Access Compliance Report

Public Rights-of-Way

Intersection ID: 30109	Main Street: HARLAND_ST	Cross Street: WANDERING_CREEK_DR	Location: E
ADA ID: 5DACA64C80E7	Ramp Type: PerpDiag	Initial Pass/Fail: Fail	Overall Compliance: No
Severity Score: 33.75			
Codes/Mitigation Info/Possible Solution		Field Measurements/Component Compliance

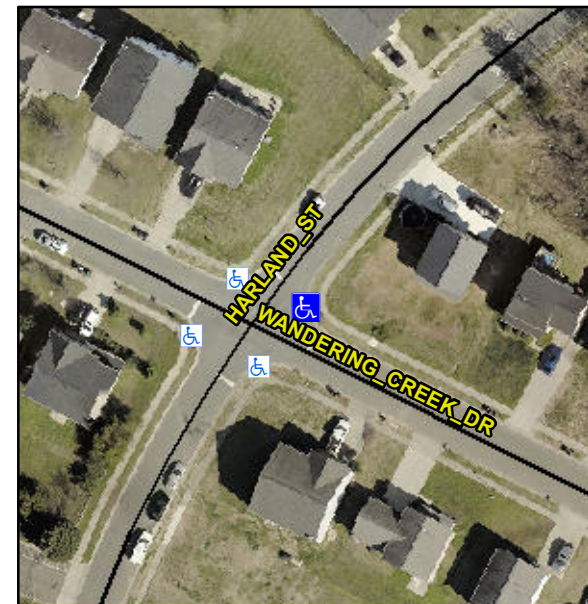
Not Found, R304.5.1, R304.5.3

Compliance	Description	Data	Compliance	Description	Data
N/A	Ramp Length (in)	48.0	Yes	Ramp Slope (%)	5.0
No	Ramp Width (in)	39.0	No	Ramp XSlope (%)	7.0
N/A	Flare Type LT	N/A	N/A	Flare Type RT	N/A
N/A	Flare Slope LT (%)	N/A	N/A	Flare Slope RT (%)	N/A
N/A	Flare Traversable LT?	N/A	N/A	Flare Traversable RT?	N/A
N/A	Landing Length (in)	N/A	N/A	DWS Provided?	N/A
N/A	Landing Width (in)	N/A	N/A	DWS Contrast?	N/A
N/A	Landing Slope (%)	N/A	N/A	DWS Length (in)	N/A
N/A	Landing X Slope (%)	N/A	N/A	DWS Full Width?	N/A
N/A	Landing Curb? (Y/N)	N/A	N/A	DWS Offset (in)	N/A
N/A	Shared Landing?	N/A			
N/A	Gutter Ponding?	N/A	N/A	Gutter Slope (%)	N/A
N/A	Gutter Lip Ht (in)	N/A	N/A	Gutter X Slope (%)	N/A
N/A	Painted X Walk1?	No	N/A	Painted X Walk2?	No
	X Walk 1 Direction	To NW		X Walk 2 Direction	To SW
N/A	X Walk 1 Width (in)	N/A	N/A	X Walk 2 Width (in)	N/A
	X Walk 1 Slope (%)	1.9		X Walk 2 Slope (%)	7.8
	X Walk 1 X Slope (%)	7.1		X Walk 2 X Slope (%)	0.9

N/A	Ramp inside XWalk1?	N/A	N/A	Ramp inside XWalk2?	N/A
	Road Slope (%)	6.6	N/A	Clear Space?	N/A
	Road X Slope (%)	4.6	N/A	Clear Space to XWalk (in)	N/A
N/A	Any Obstructions?	N/A	N/A	Storm Grate/Utility Hazard?	N/A
	Obstruction Type			Storm Grate/Utility Type	
		N/A			N/A
			Yes	Surface Condition? (G/P)	Good

Remove & Replace Curb Ramp With Two New Directional Ramps or Equivalent.
